# Gatwick Airport Northern Runway Project

## Second Change Application Report

Application Document Ref: 10.47

**Figure 1: Location of the On-airport WWTW**

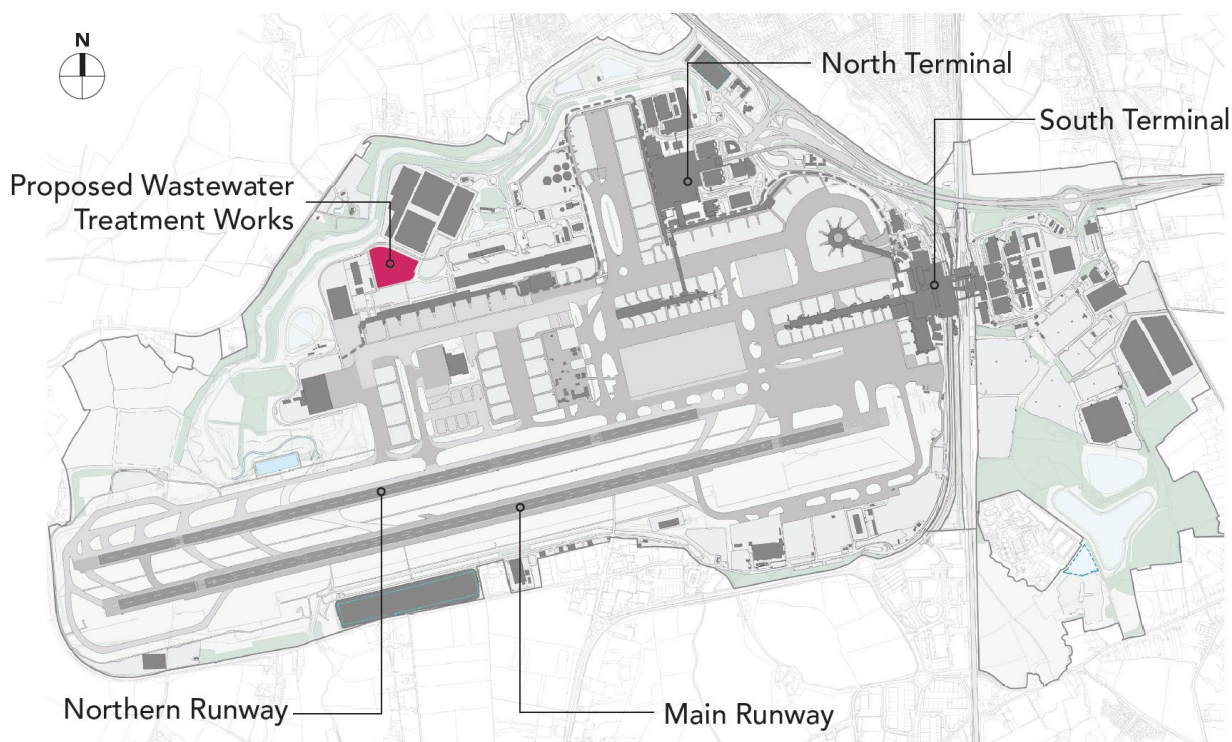
2.1.2 The location of the proposed On-airport WWTW is shown in pink in **Figure 1** below.

- Provision of an On-airport Wastewater Treatment Works ('WWTW'), located within existing Self Park North car park shown on **ES Figure 4.2.1b** [[REP1-019](#)] and in **Figure 1** above.

**Figure 2: Indicative Layout of the On-airport WWTW**

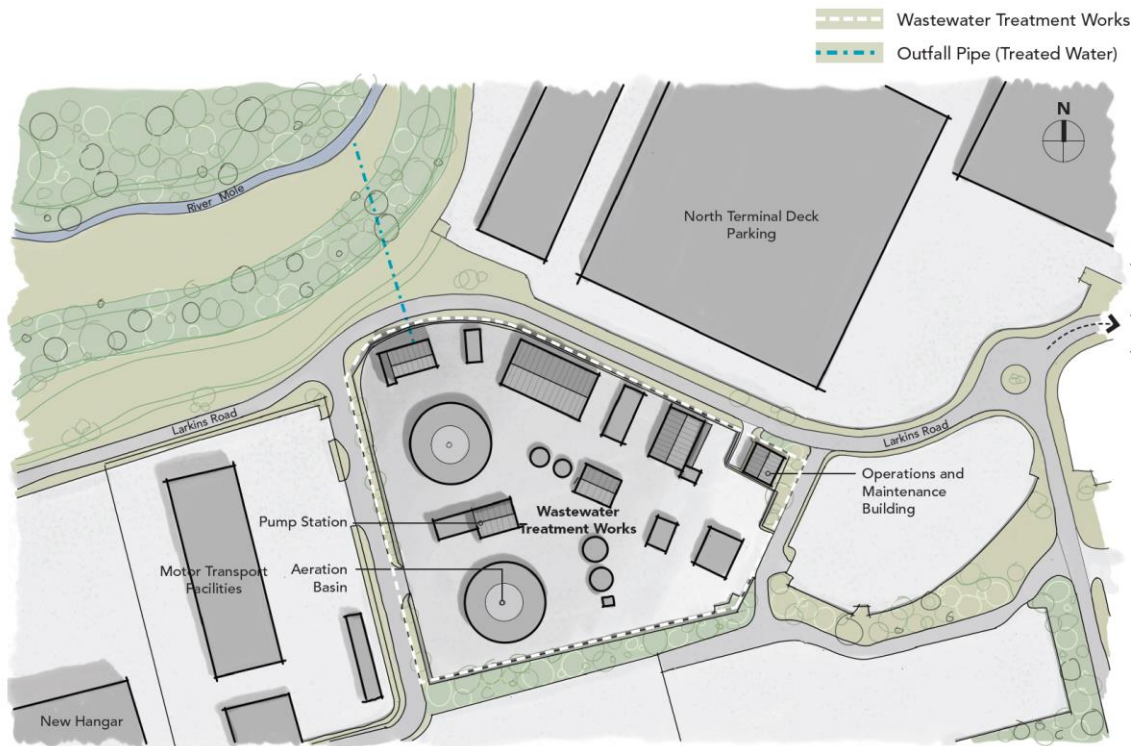
2.2.8 The physical elements within the On-airport WWTW are shown on the indicative layout in **Figure 2** below.
